Planning Commission Staff Report

Subject: Treasure
Project #: PL-08-00370
Authors: Francisco Astorga, AICP, Senior Planner
Date: 25 October 2017
Type of Item: Administrative – Conditional Use Permit Refinement 17.2 Update

During the [October 11, 2017](#) Planning Commission meeting, the Commission requested that the Planning Department to provide an analysis of Refinement 17.2 and the Plans provided on the Sweeney Properties Master Plan (SPMP) produced by Eugene Woodruff. Staff prepared the following exhibits to allow the Planning Commission to compare the original SPMP approval plans/documents (Master Plan/Woodruff) and Refinement 17.2:

**TOWN LIFT MIDSTATION
& CREOLE SITE PLAN**
SWEENEY PROPERTIES MASTER PLAN

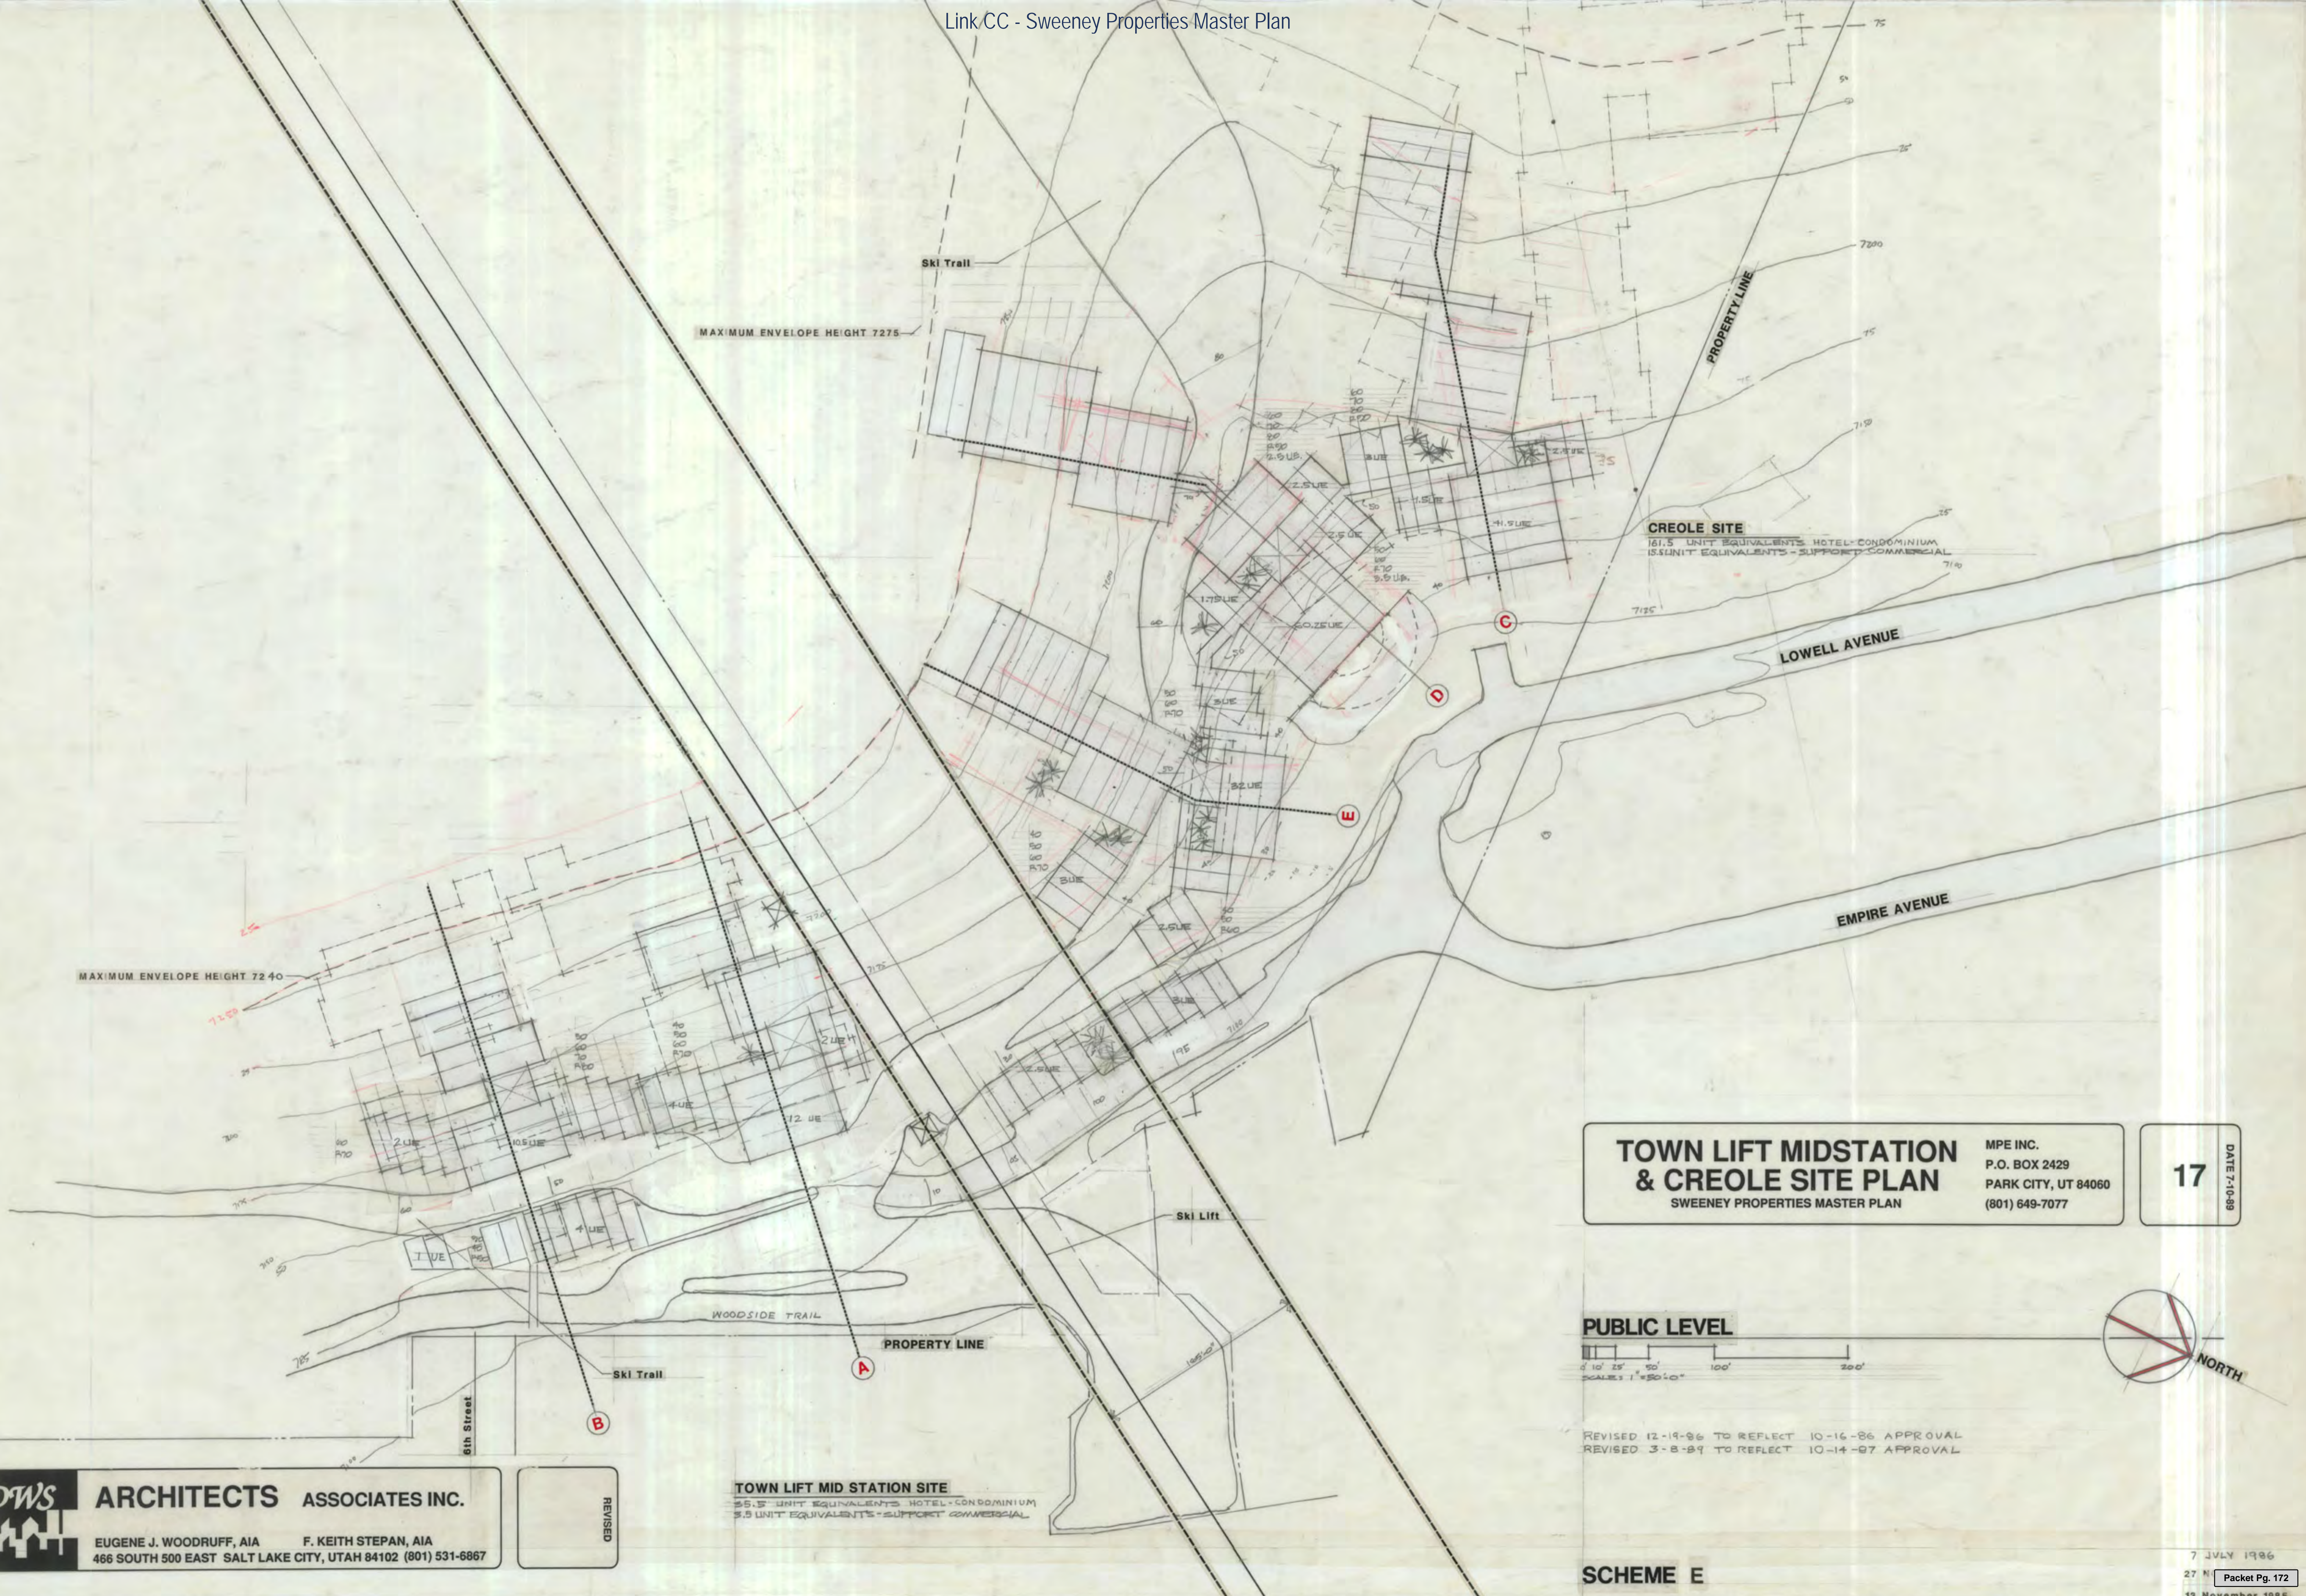
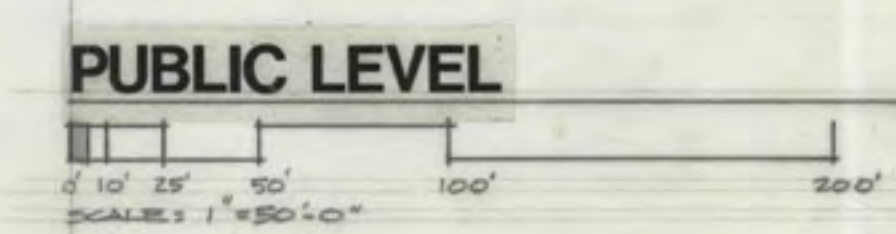
2. The various site plans show a series of buildings located at both identified sites.
3. Creole-Gulch site plans show a main building connected with 3 separate wings and 3 smaller buildings; see sheet 17.

4. Mid-Station site plans show a main building with 2 separate areas and two smaller buildings; see sheet 17.
5. Creole-Gulch site plans show the creole ski run running through 2 wings of the main building. Site plan sheet 22 has the following note: *“Where skit trail passes through building, opening to be a minimum of 40’-0” horizontal, 20’-0” vertical.”*

7. Both sites on sheet 17 (main site plan) show five (5) specified building sections. Building section A and B are within the Mid-Station site. Building section C, D, and E are within the Creole-Gulch site.

GREATER PARK CITY COMPANY		SHEET NO.
	TOWNLIFT EASEMENTS		28
	<small>R.J. SORENSON ASSOCIATES DRAWN BY J.L.S. DATE 3-24-87 Engineers and Surveyors JOB NUMBER 205 APPROVED BY _____ Salt Lake City, Utah CHECKED BY JPB FILE NO. _____</small>

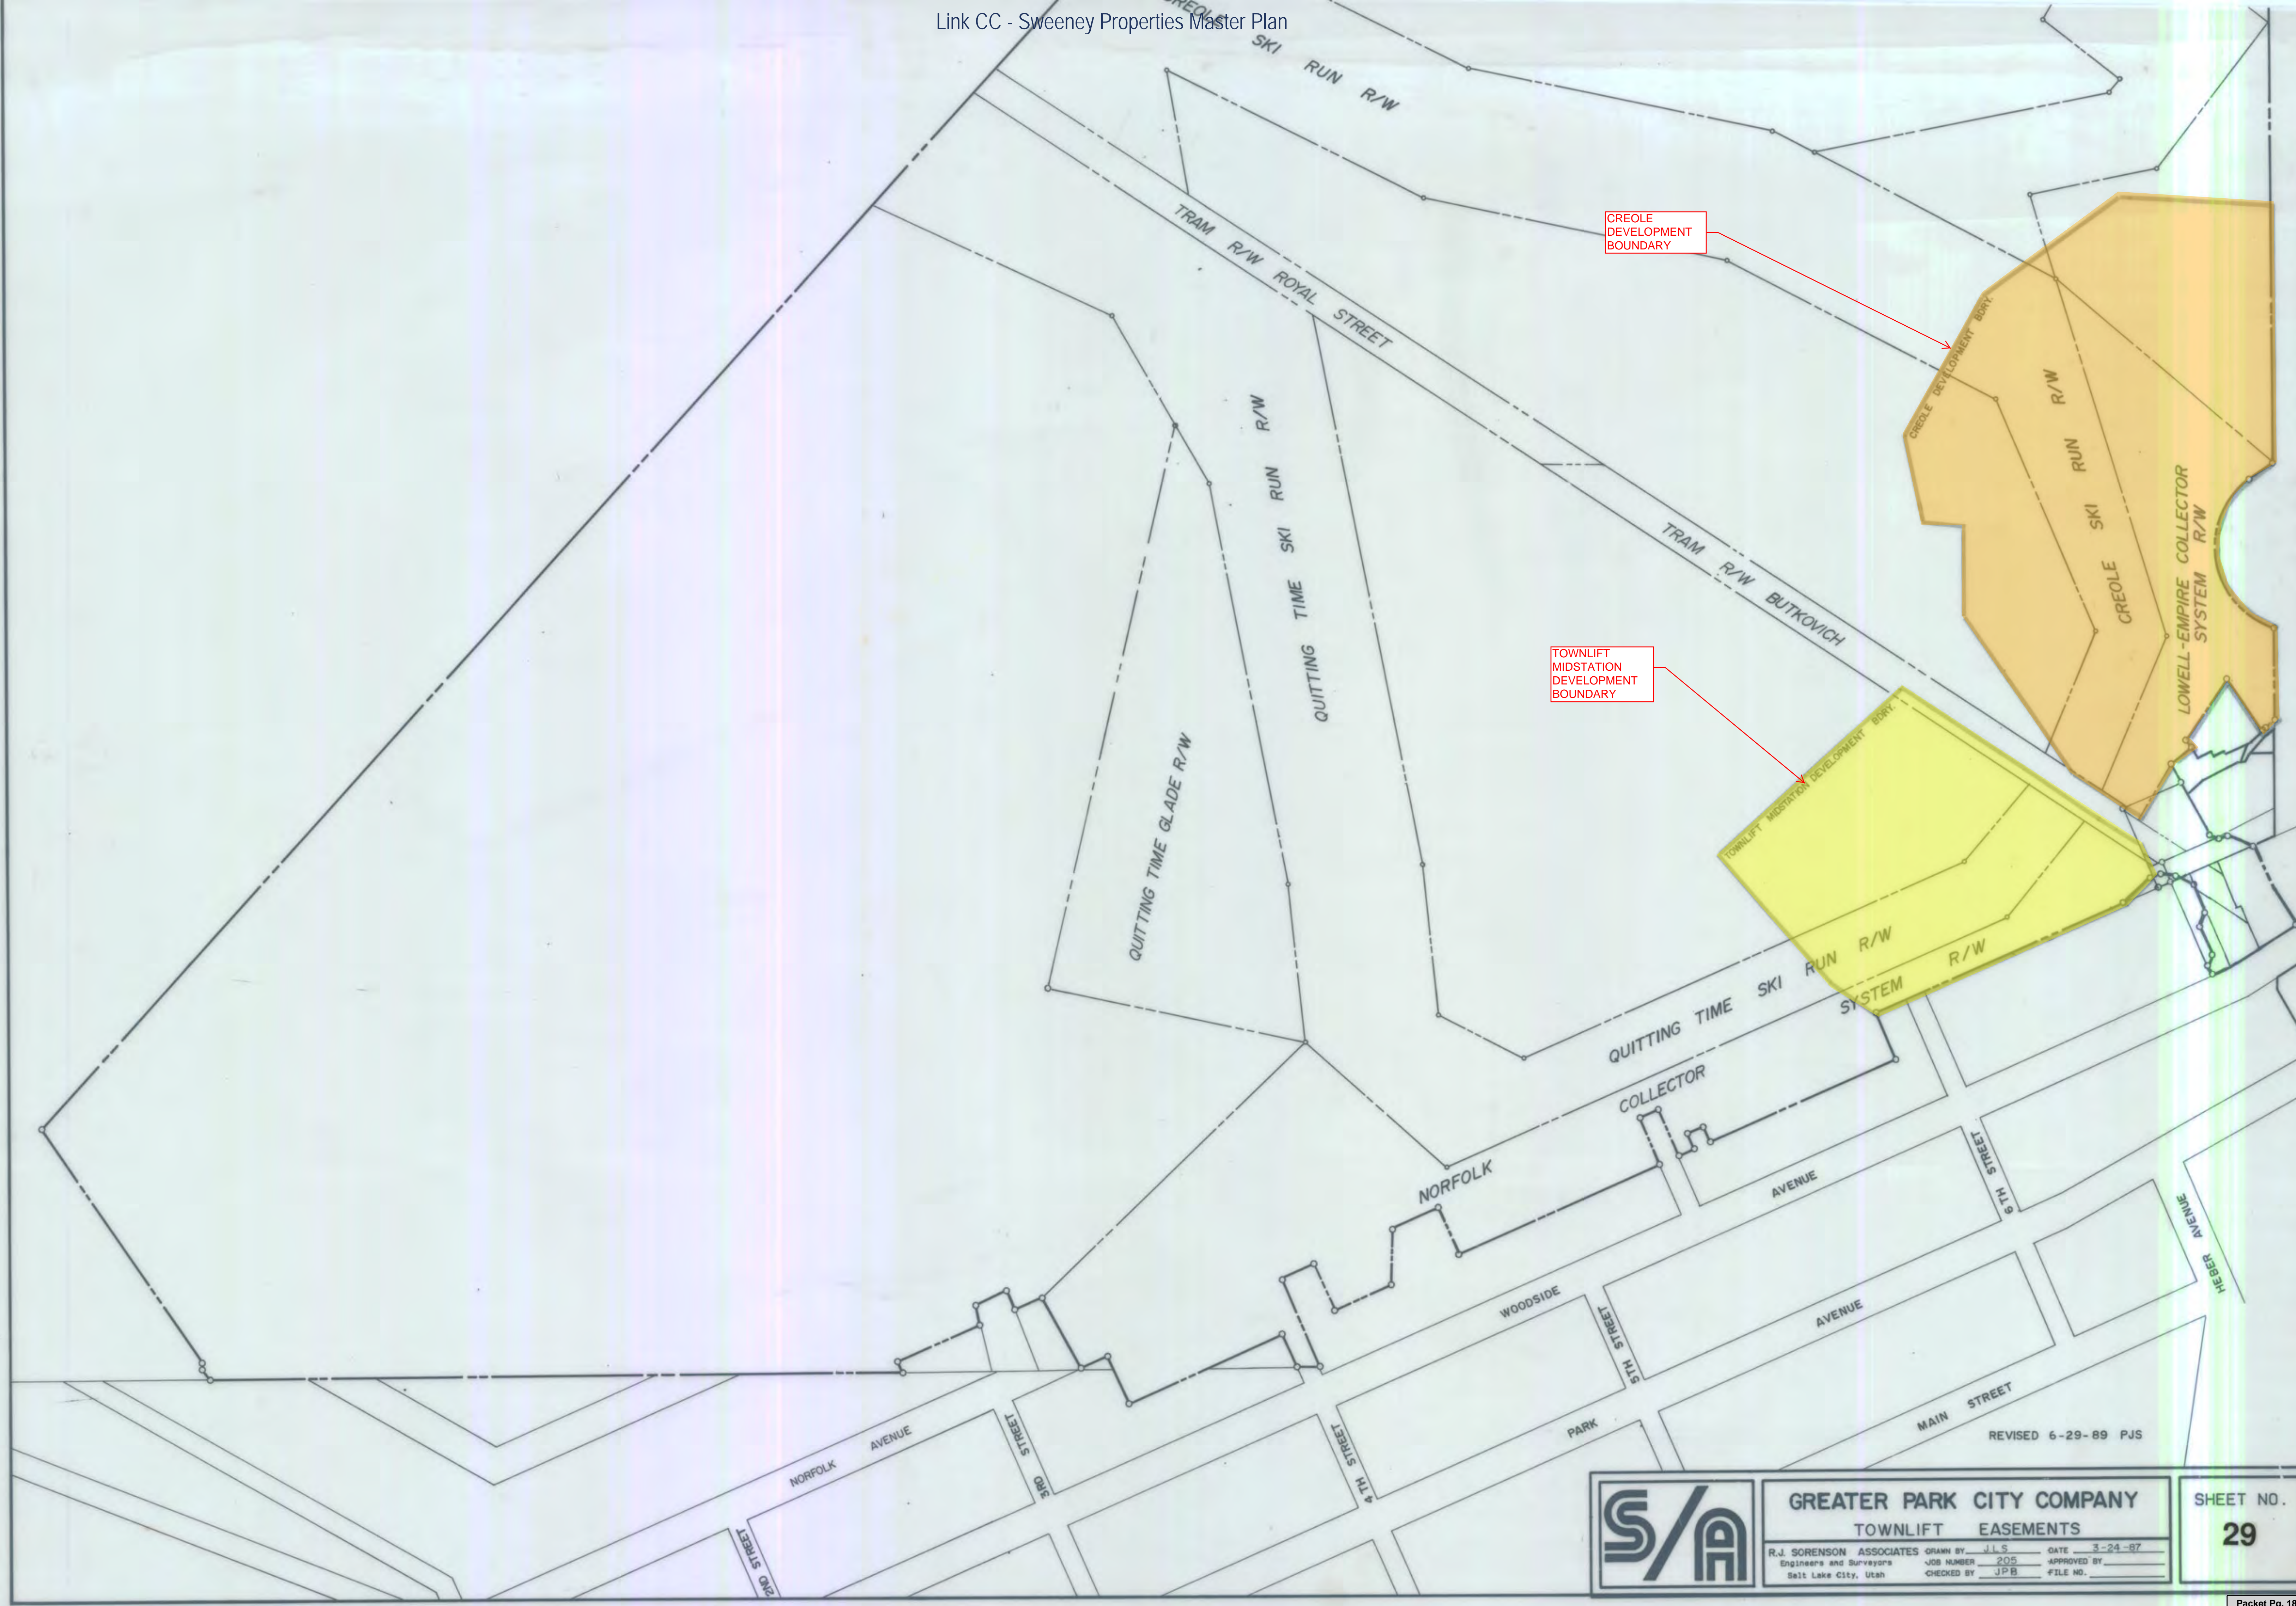
27. Sample elevation C and E show compliance with the building sections/height zone plan, measured from existing grade. Sample elevation D was not updated/amended to show the adopted height as the change is indeed reflected on the building section sheet 17 and height zone plan sheet 22.
28. Sheet 28 and 29 show each ski run bi-furcating its corresponding site as well as the development boundaries.
